Prepared for:
City of Concord

July 2015

Transportation Impact Assessment

Golden State Lumber Concord Facility

Figure 11

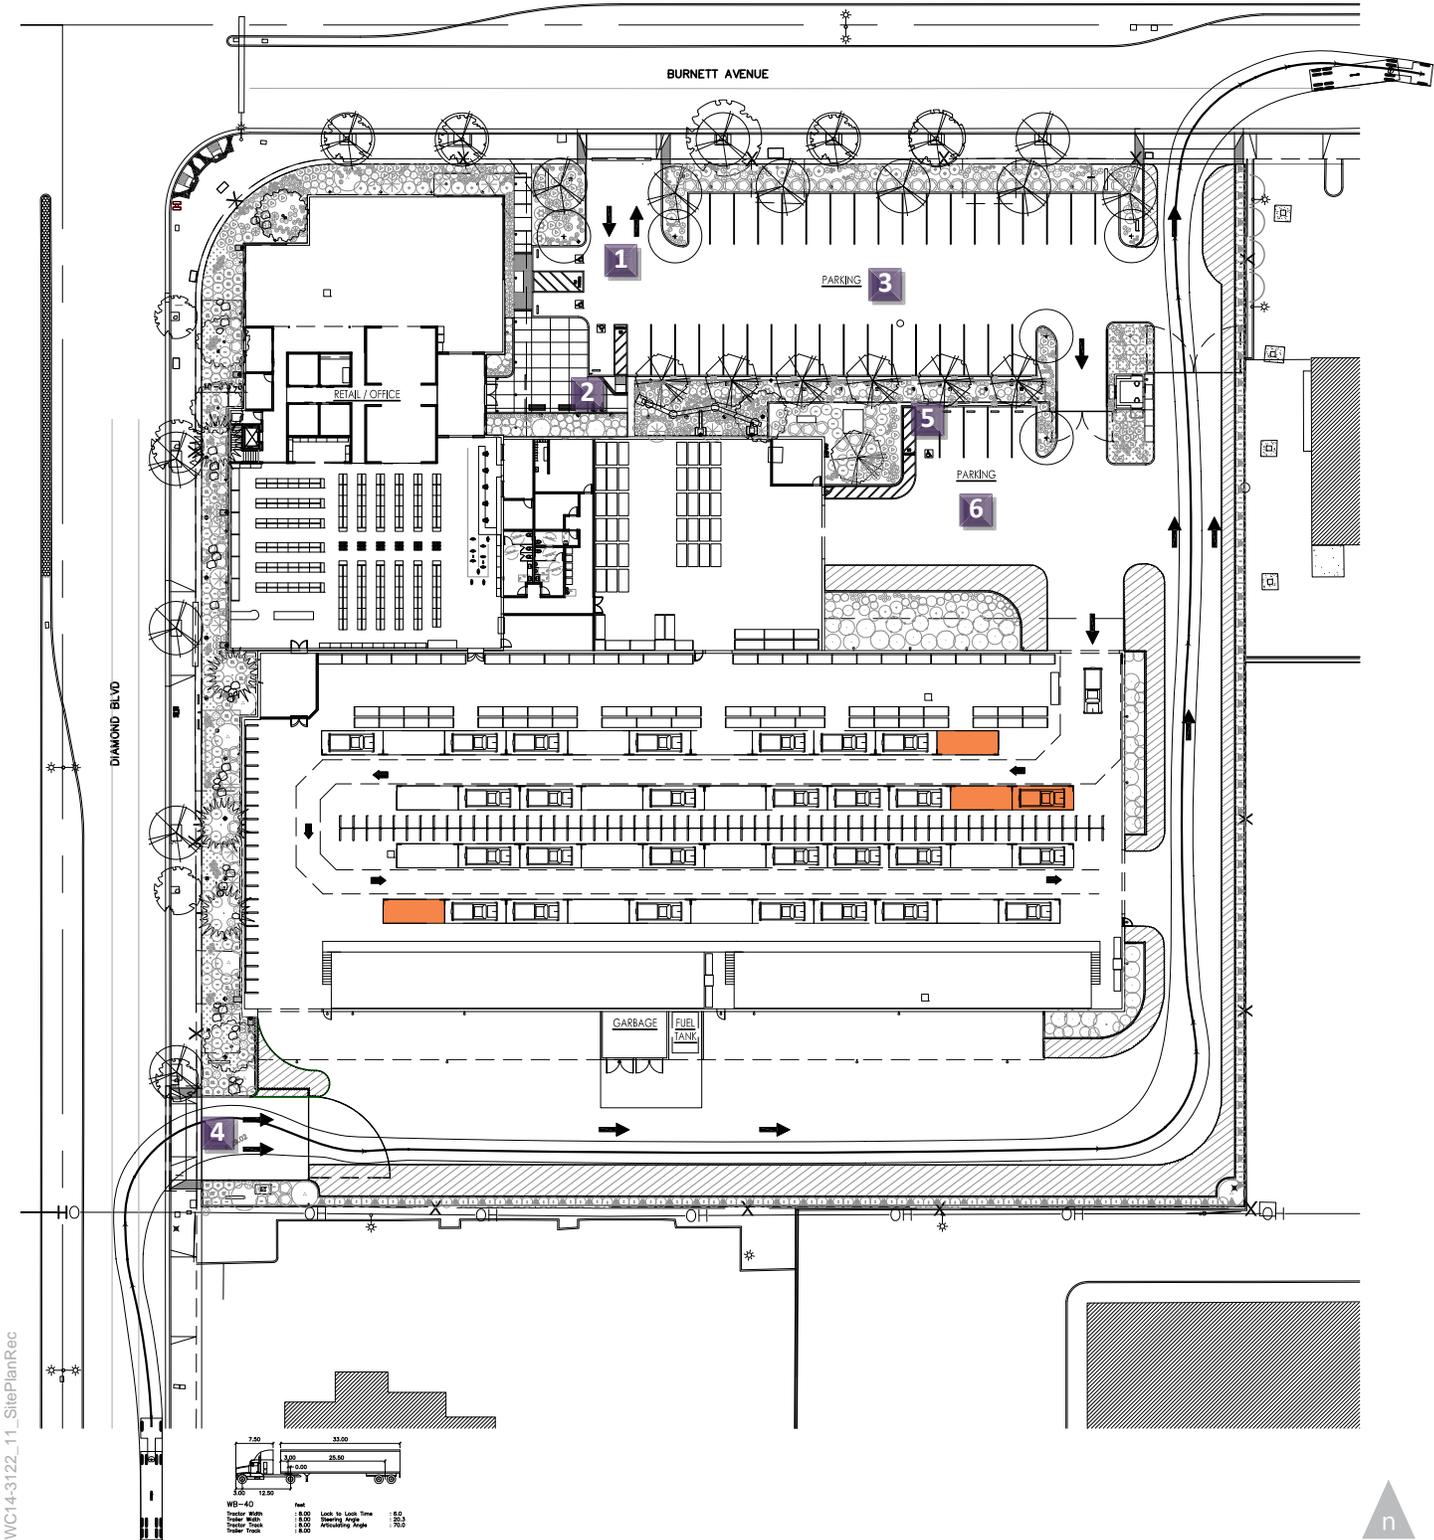
Figure 11 also details the results of the AutoTurn analysis for a large semi-truck around the perimeter of the site. A simulation of a truck with a trailer (42 feet total in length) was the largest vehicle that was able to enter through the main entrance on Burnett Avenue, traverse the parking lot and circulate through Shed 2.

Condition of Approval 5: Remove the four (4) highlighted parking spaces on **Figure 11** to allow vehicles to easily navigate the site.

Recommendation: Consider relocating the interior ADA-accessible parking space to the main parking area near the front entrance to the building.

Recommendation: Develop a parking management plan to establish desired locations for employee parking that is responsive to customer parking patterns.

Develop a Parking Management Plan

Create a Routing Plan for Delivery/Large Vehicles

Relocate Parking Stalls to Planted Area along Shed 2
